Title - Sujet Interpretation Center-Mary's Point,	
Solicitation No. - N° de l'invitation EC015-180296/A	Amendment No. - N° modif. 001
Client Reference No. - N° de référence du client EC015-180296	Date 2017-07-05
GETS Reference No. - N° de référence de SEAG PW-\$PWB-100-4143	
File No. - N° de dossier PWB-7-40025 (100)	CCC No./N° CCC - FMS No./N° VME
Solicitation Closes - L'invitation prend fin at - à 02:00 PM on - le 2017-07-13	
Time Zone Fuseau horaire Atlantic Daylight Saving Time ADT	
F.O.B. - F.A.B. Plant-Usine: <input type="checkbox"/> Destination: <input checked="" type="checkbox"/> Other-Autre: <input type="checkbox"/>	
Address Enquiries to: - Adresser toutes questions à: MacDonald, Anne (PWB) D.	Buyer Id - Id de l'acheteur pwb100
Telephone No. - N° de téléphone (902) 626-4949 ()	FAX No. - N° de FAX (506) 636-4376
Destination - of Goods, Services, and Construction: Destination - des biens, services et construction:

Addendum # 1
EC015-180296/A
July 5, 2017

THE FOLLOWING CHANGES TO THE PLANS AND SPECIFICATIONS ARE TO BE INCORPORATED AND BECOME PART OF THE CONTRACT DOCUMENTS.

DRAWING SK-1

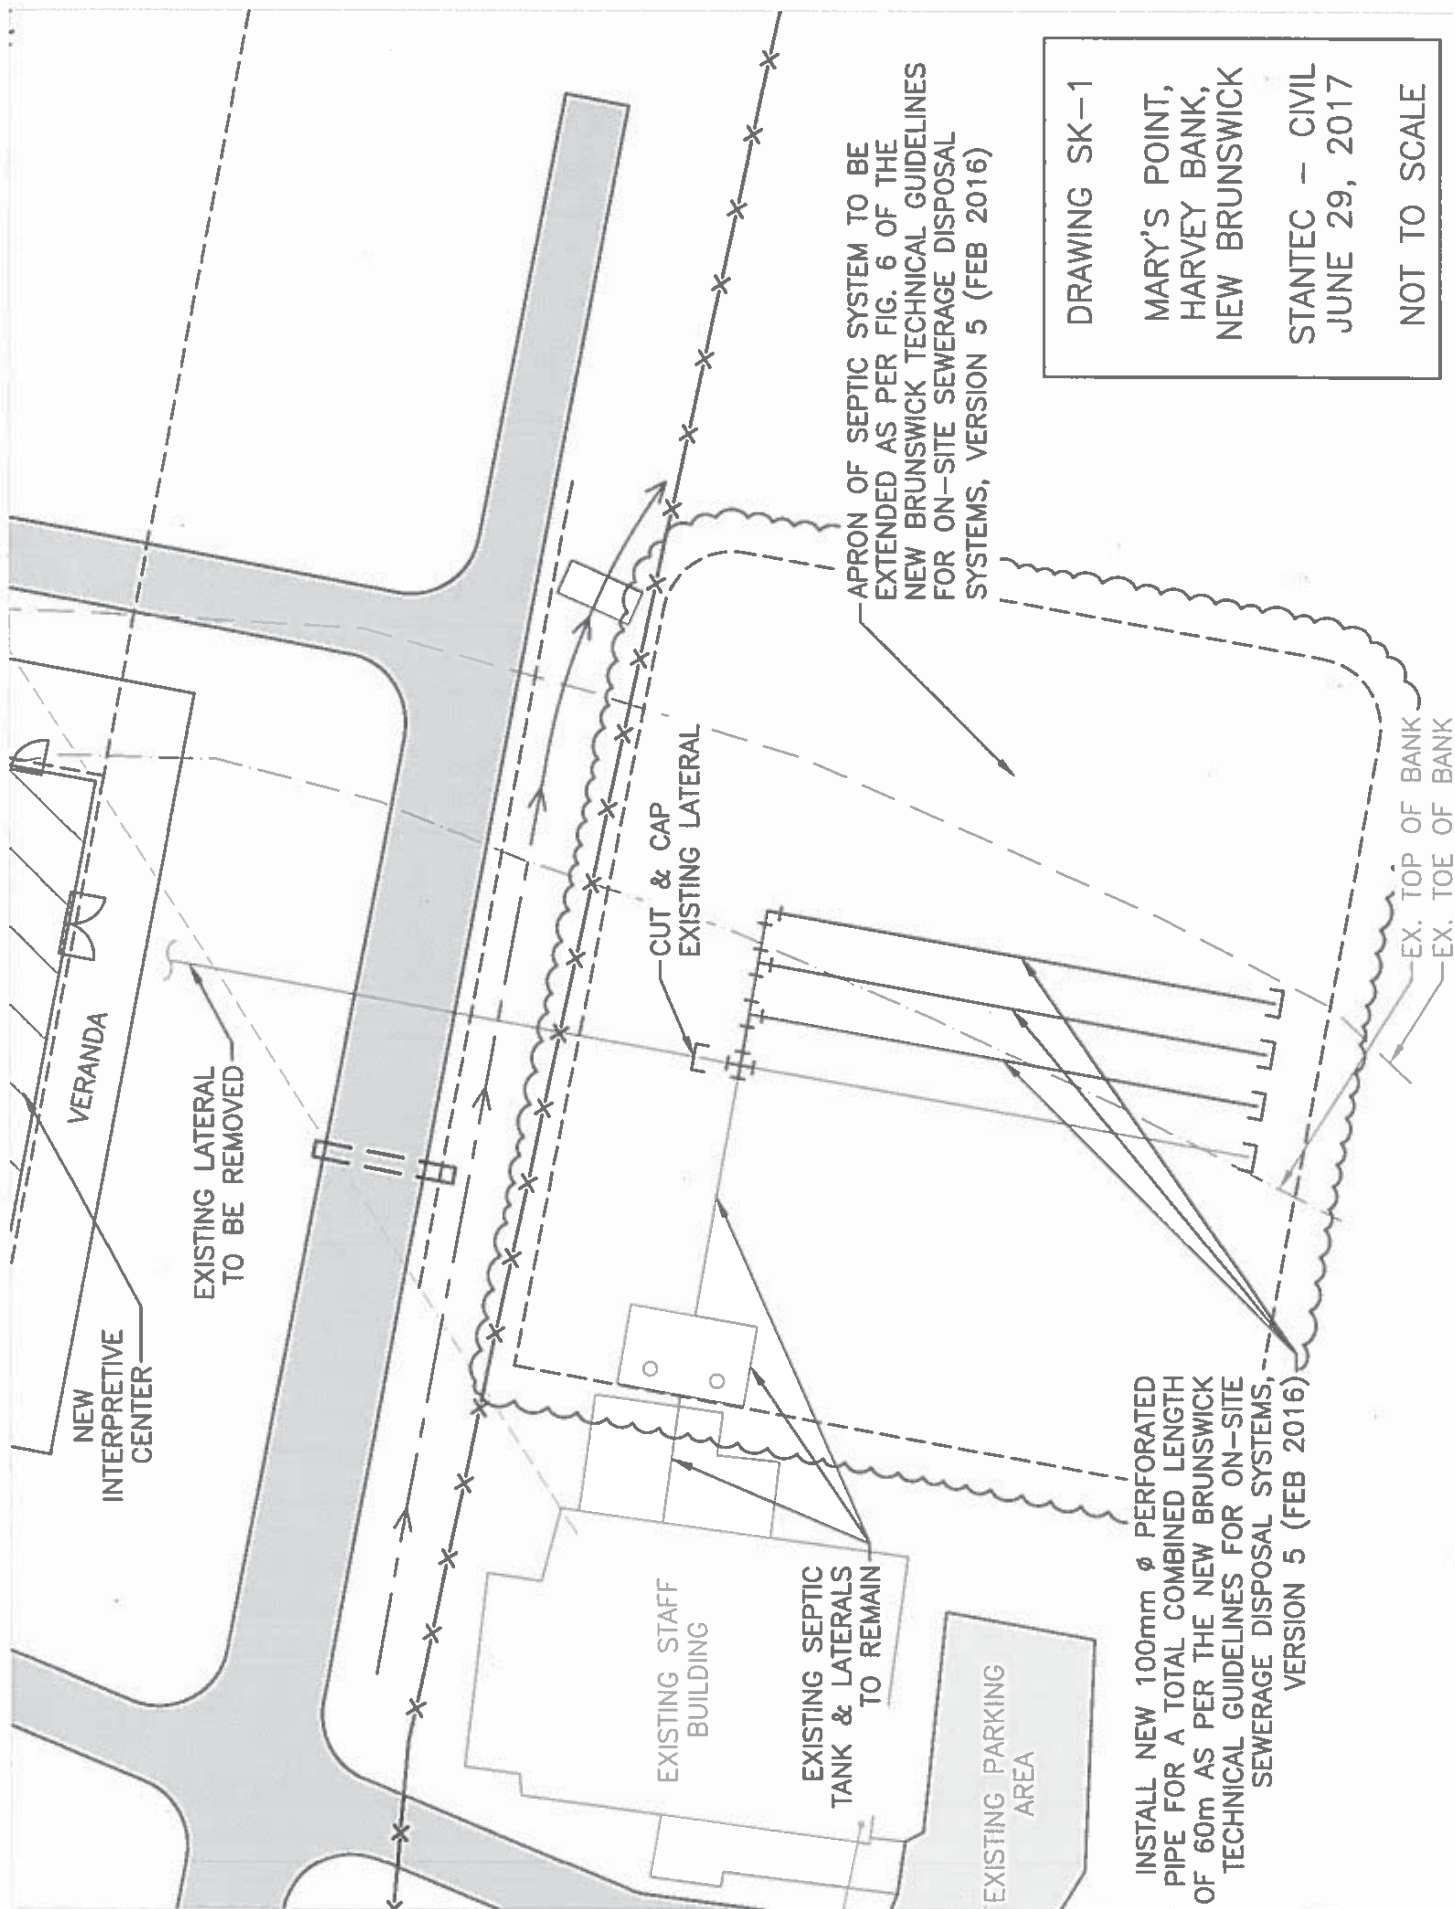
- Item 7 The existing septic system is to be modified to address conflicts with the proposed building. The existing 100mm diameter PVC perforated pipe is to be cut and capped at the limit of construction as shown on the attached Drawing SK-1. The Contractor is to confirm the location of the existing septic system and perforated pipe in the field prior to construction. New 100mm diameter PVC perforated pipe is to be installed and connected to the existing distribution system for a total perforated pipe length of 60m, maximum 15m absorption trench lengths each, offset 1.5m centerline to centerline of each trench, and installed as per the *New Brunswick Technical Guidelines for On-site Sewage Disposal Systems* by a certified Contractor. Refer to Figure 6 of the *New Brunswick Technical Guidelines for On-site Sewage Disposal Systems*. Modification of the existing septic system must be approved by the Department of Public Safety prior to construction.
